Malting and Distilling Facility RFP

Q&A
2/15/2016

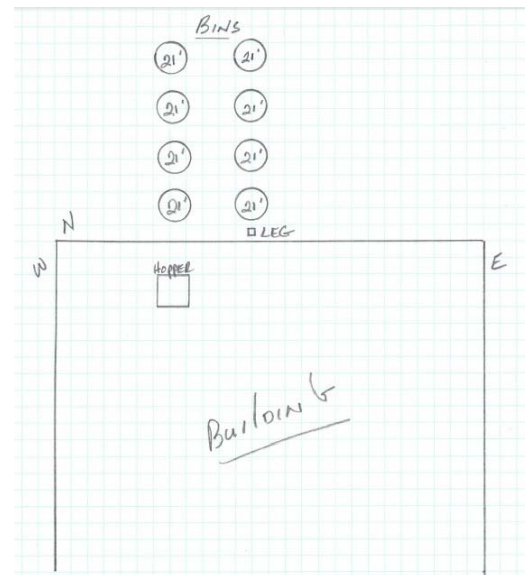
8. Q: Can the (8) 8,000 Bushels bins be installed per the attached drawing for better conveying flow and to save money on extra conveying equipment?

A: This is a possible configuration for the bins. There are other possible configurations.
